UNITED STATES PATENT AND TRADEMARK OFFICE

APPLICATION NO.	FILING DATE	FIRST NAMED INVENTOR	ATTORNEY DOCKET NO.	CONFIRMATION NO.
09/942,673	08/31/2001	Eric Bouffard	P 283115	7804

Office Action Summary

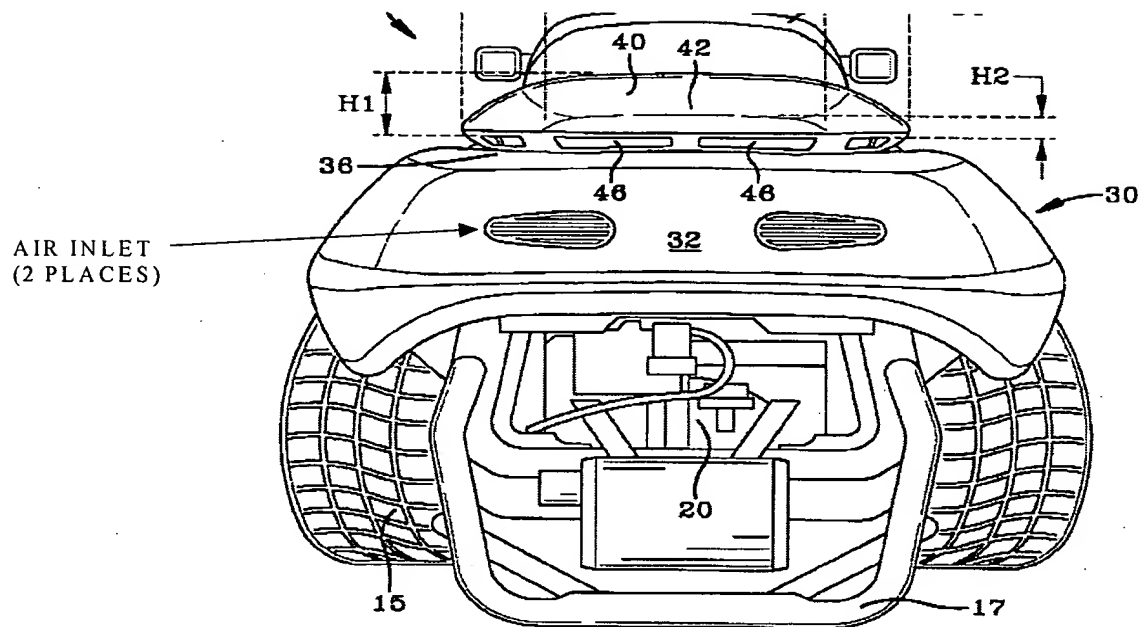
Further, note that Peter teaches an aperture (see following sketch) on the rear side of a rear fender (32). An aperture is advantageous on a rear fender in that it allows improved air flow to internal located components. Note that the aperture of Peter is proximal the air intake ("upstream" of 13) going to the carburetor (see English Language Abstract) of Japanese Patent 60-153418. Note also that the air intakes of Peter are above the rear wheels of Peter (Figure 3). This will improve airflow to the carburetor of Japanese Patent 60-153418. Japanese Patent 60-153418 does not explicitly mention an engine. However, the Examiner takes Official Notice that a carburetor is associated with an engine. The purpose of a carburetor is to provide correct the correct air/fuel ratio to an engine and to regulate the density of the air/fuel mixture to the engine by use of a throttle valve to regulate power output of the engine. This may be seen on many small tractors and mowers, as well as pre-mid 80's vintage automobiles.

Further, note that Peter teaches an aperture (see above sketch) on the rear side of a rear fender (32). An aperture is advantageous on a rear fender in that it allows improved air flow to internal located components. Note that the aperture of Peter is proximal the air intake (piping "upstream" of 13) going to the carburetor (see English Language Abstract) of Japanese Patent 60-153418. Note also that the air intakes of Peter are above the rear wheels of Peter. This will improve airflow to the carburetor of Japanese Patent 60-153418. Japanese Patent 60-153418 does not explicitly mention an engine. However, the Examiner takes Official Notice that a carburetor is associated with an engine. The purpose of a carburetor is to provide correct the correct air/fuel ratio to an engine and to regulate the density of the air/fuel mixture to the engine by use of a throttle valve to regulate power output of the engine. This may be seen on many small tractors and mowers, as well as pre "mid-80's vintage" automobiles.

24. Regarding the Peter reference, the Applicant has misunderstood what the Examiner is terming "openings". The Applicant on page 15 of paper 4 appears to believe that reference number 46 are the "openings" being referred to by the Examiner on paper 2. However, the "openings" are actually "openings" located below reference number 46. To clarify this, the Examiner has added a sketch in this Office Action illustrating where these "openings" are actually located.
